POWER PLANT - VARIOUS - TO ANNOUNCE THE INTRODUCTION OF MODIFIED SUPPORT BRACKETS AND MOUNTING RAFTS ON THE FAN CASE - CATEGORY CODE 6 - MOD.ENG-71-0114

V2500-ENG-71-0114

View AB (Figure 2) - Relay box mounting bracket (Rotated thru 90 degrees for convenience) - Before alteration
Fig.3

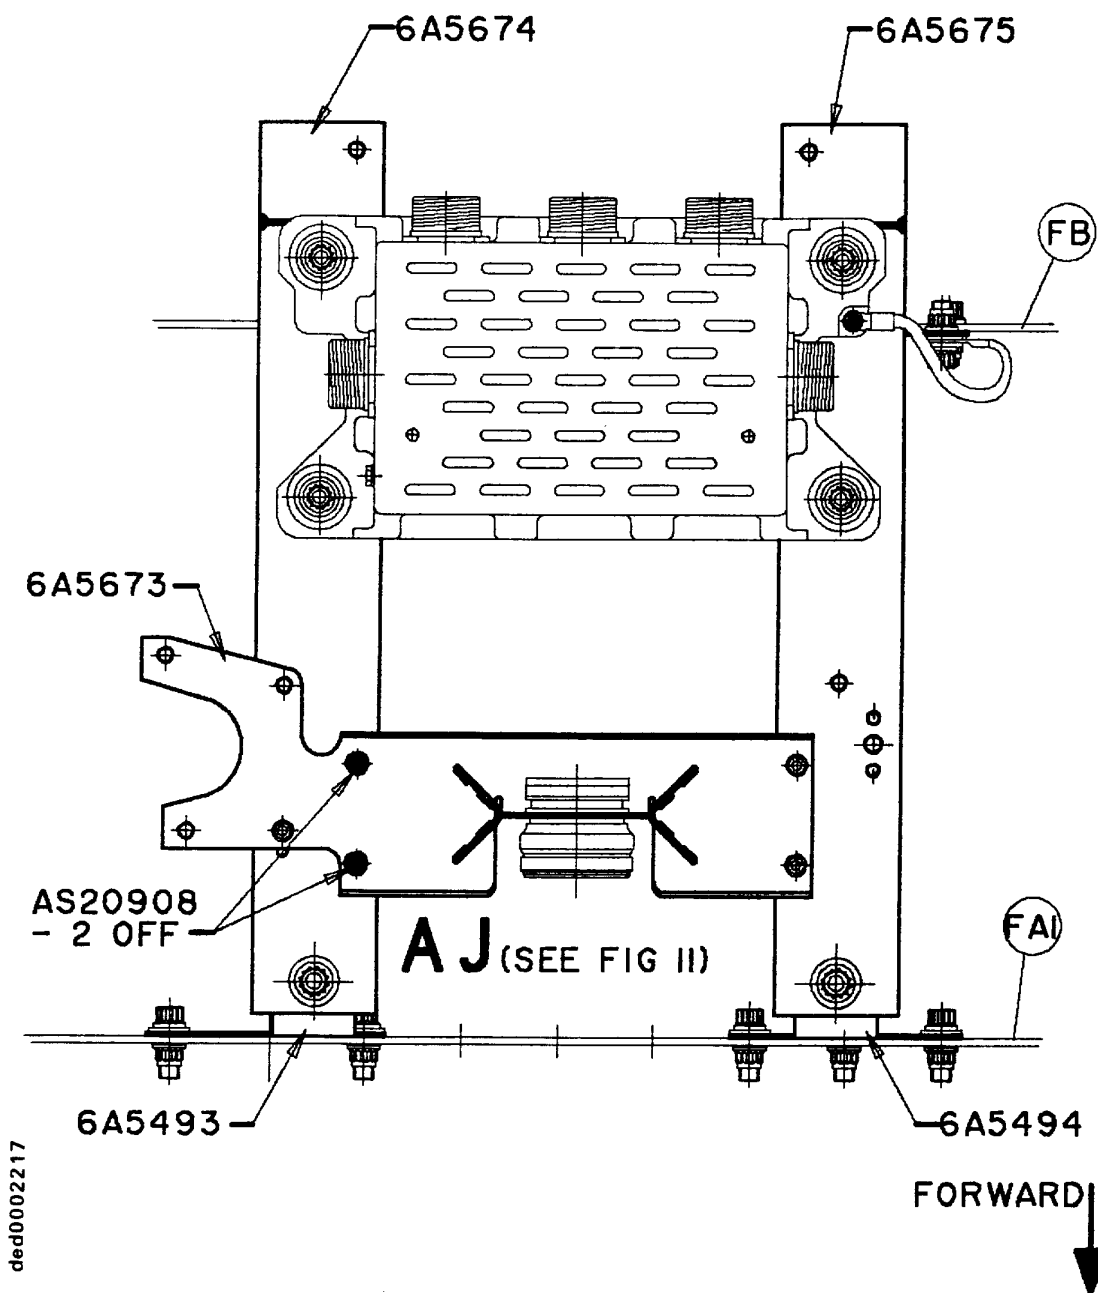
- (1) The angle brackets which support the forward end of the relay box mounting rafts are replaced by two brackets which are increased in height by 0.063 in. (1,6 mm).
- (2) A combined and strengthened disconnect bracket replaces the existing cross-raft and separate bracket.

The existing relay-box mounting rafts are replaced. The upper raft has two anchor nuts in a different position and the lower raft has two anchor nuts added.

View AC (Figure 2) - Clipping bracket at right hand bifurcation - Before and after alteration
Fig.5

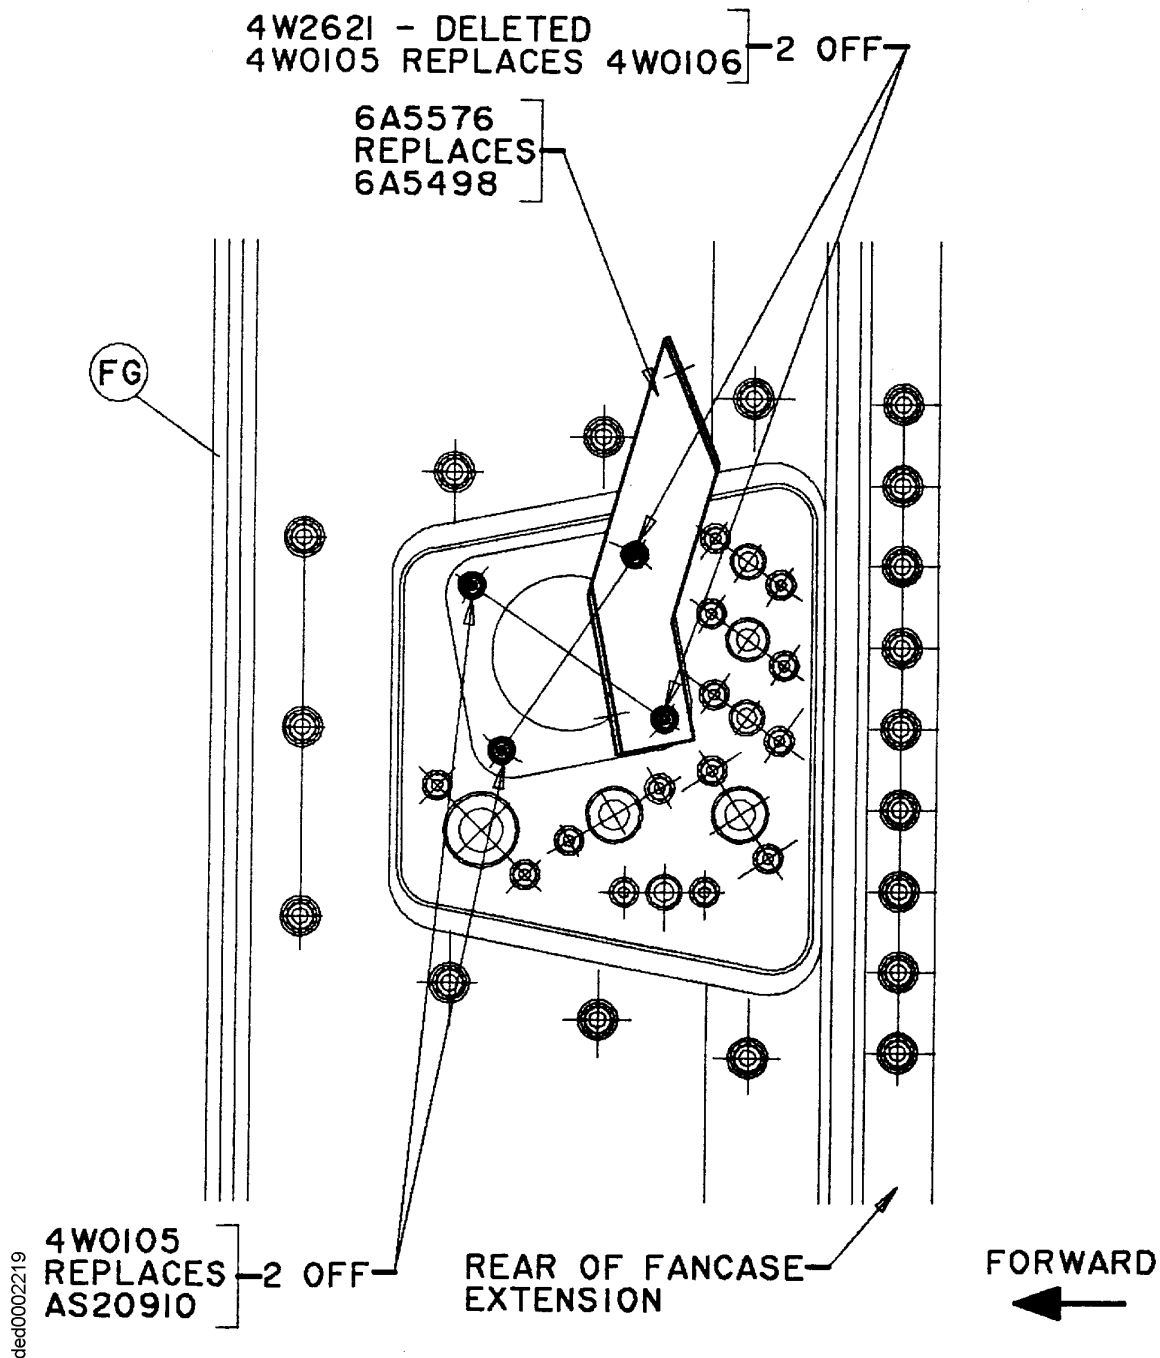
- (5) A revised clip support bracket with 0.190 in. dia. holes for the attachment bolts is introduced at the LH bifurcation box. The spreader washers used with the initial bracket are discarded. This change has also been done for the RH bifurcation box.

View AE (Figure 2) - Mounting bracket for pressure switch - Before and after alteration
Fig.7

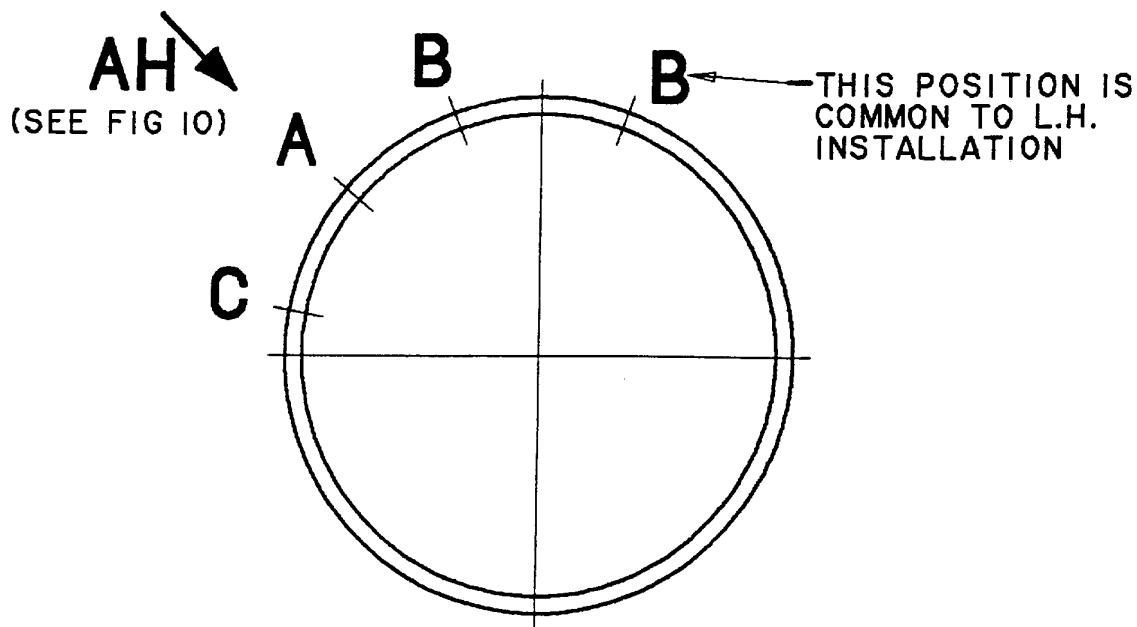
- (3) A different bracket for the oil scavenge-filter pressure-switch is introduced. The internal bend angle is increased from 85 degrees to 90 degrees.

Diagrammatic section AF (Figure 2) - Position of raft brackets (RH installation only)
Fig.8

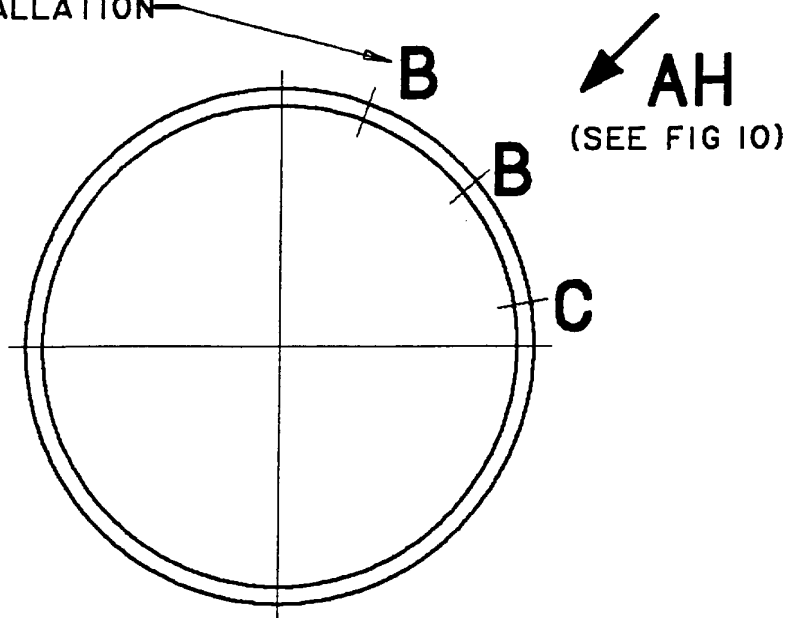
NOTE: A revised support bracket and a revised or reworked raft are necessary at the location nearest the FCOC fuel-filter cover (Refer to Figures 8, 9 and 19).

6A576I REPLACES 6A4953 (SEE FIG 10) AT POSITIONS **A** AND **B**

6A576O REPLACES 6A4952 (SEE FIG 10) AT POSITIONS **A**, **B**
AND **C**

NOTE :- FITMENT OF A NEW OR REWORKED 6A576I AND 6A576O
IS ESSENTIAL AT POSITION **A** ONLY

Diagrammatic section AG (Figure 2) - Position of raft bracket (LH installation only)
Fig.9

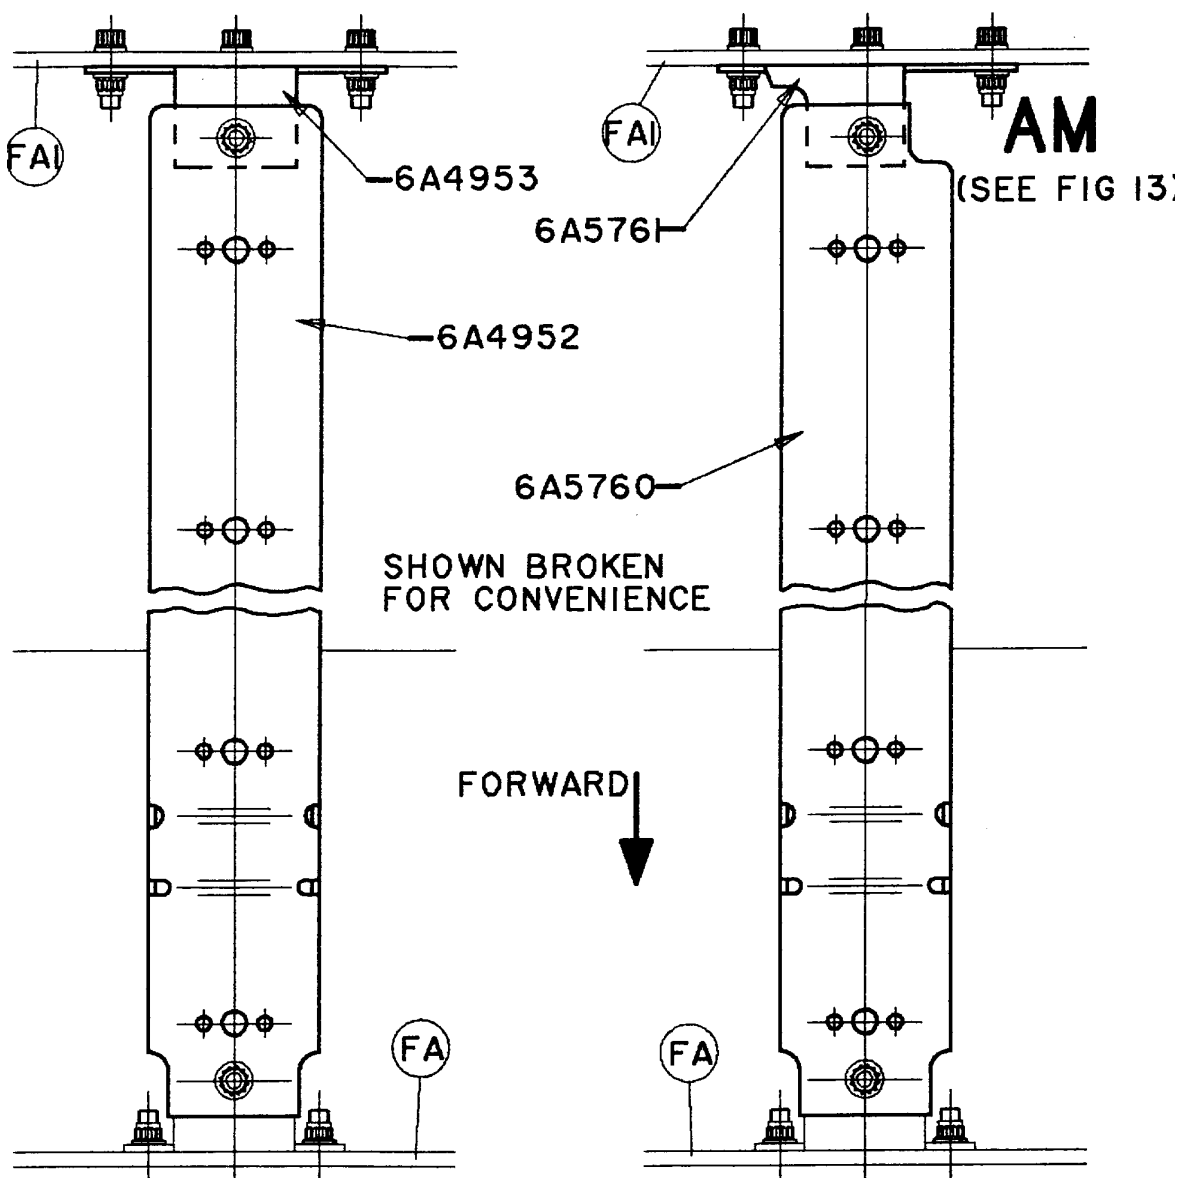
THIS POSITION IS
COMMON TO R.H.
INSTALLATION

6A576I REPLACES 6A4953 (SEE FIG 10) AT POSITIONS **B**
6A576O REPLACES 6A4952 (SEE FIG 10) AT POSITIONS **B** AND **C**

View AH (Figures 8 and 9) – Before and after alteration
Fig.10

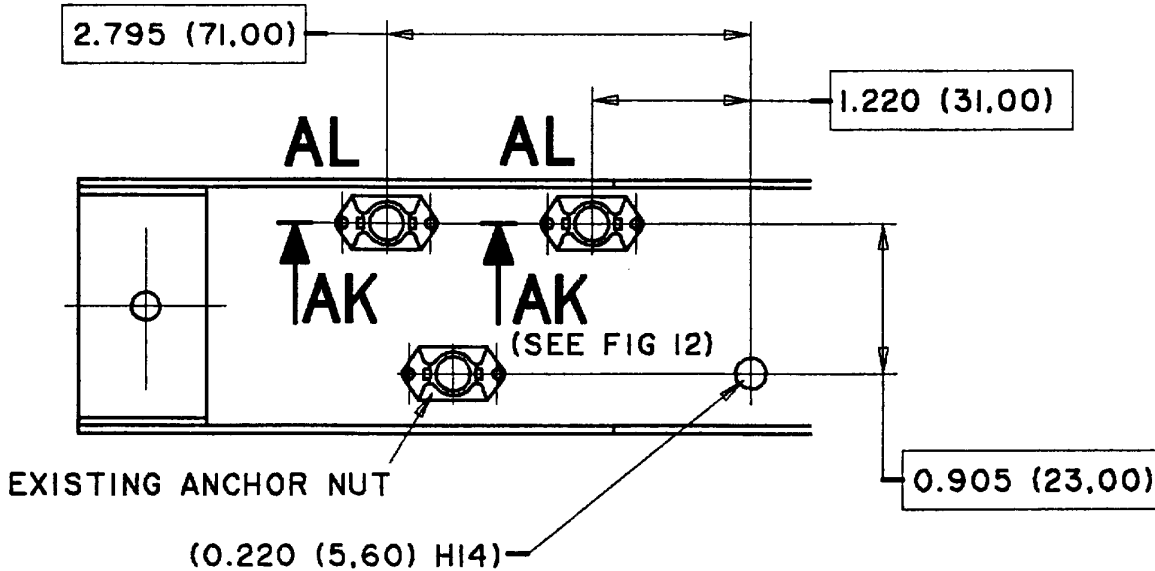
- (4) A new harness-loom mounting raft between fan case flanges FA and FA1 and located at the FCOC fuel filter-cover is introduced. A new raft support bracket bolted to flange FA1 is also introduced. The raft and bracket have a cut-out so that the adjacent cover bolt can be removed without the need to remove the bracketry.

The affected support bracket is installed at 4 locations. The mounting raft is installed at 3 locations on LH installations and 4 locations on RH installations. So that all components are the same the revised raft and brackets are introduced at all positions.

Rework of relay-box mounting brackets (6A4740)
 Fig.11

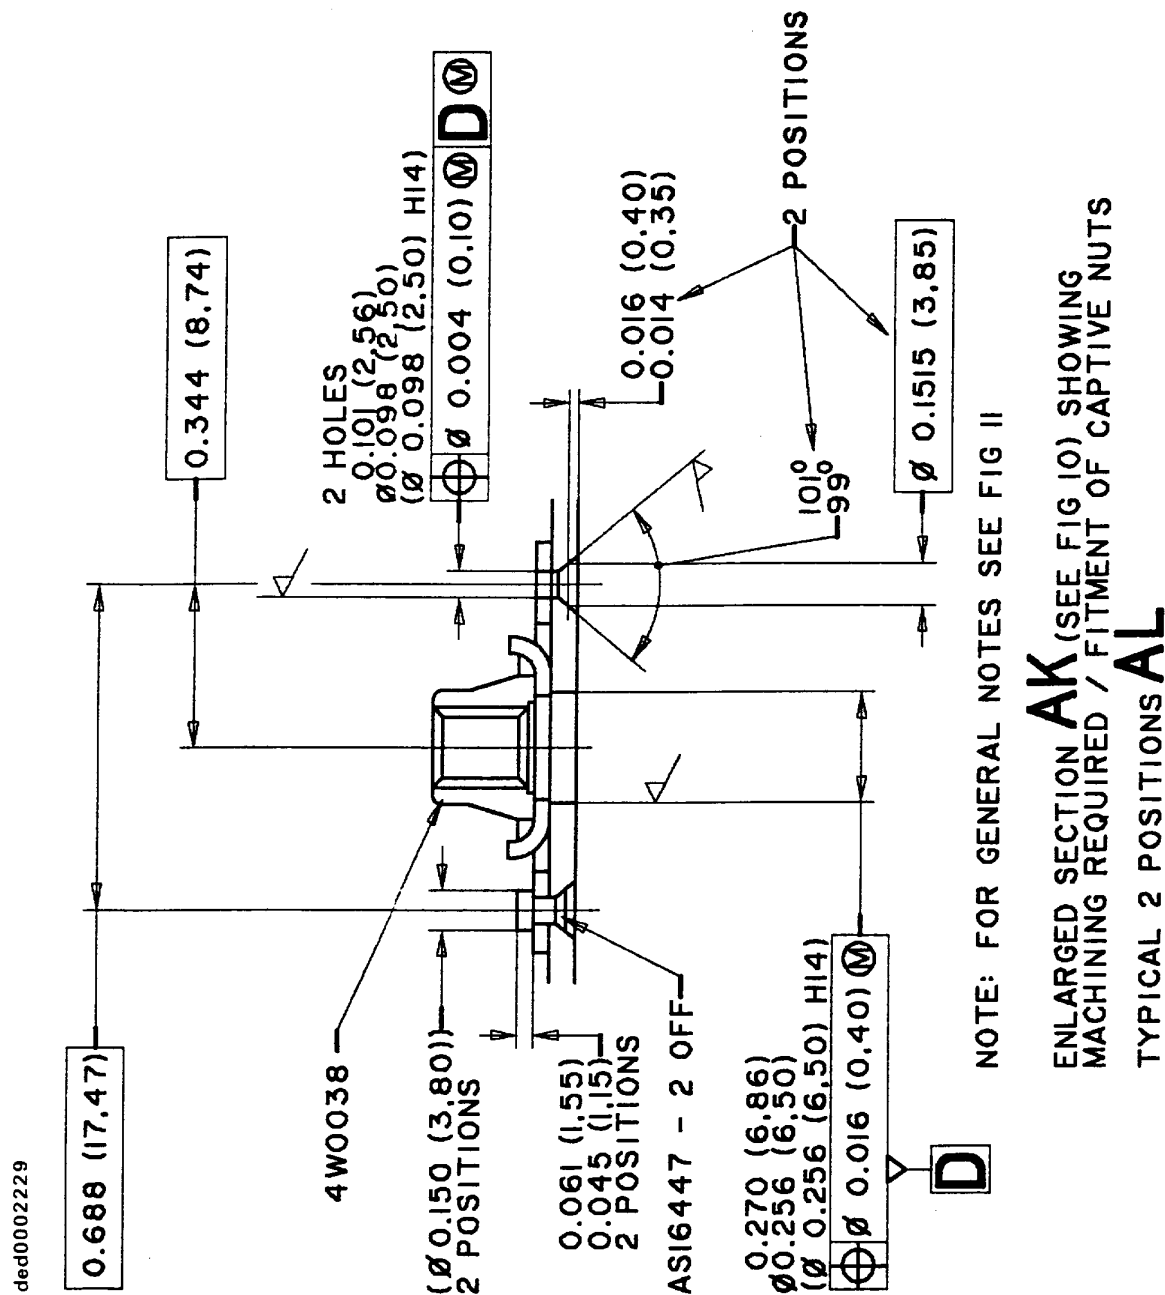
Existing lower rafts can be reworked.

- (1) Rework the lower mounting rafts of the relay box.
 - (a) Refer to Figures 11 and 12.
- (2) Rework the mounting rafts of the harness loom.
 - (a) Refer to Figure 13.
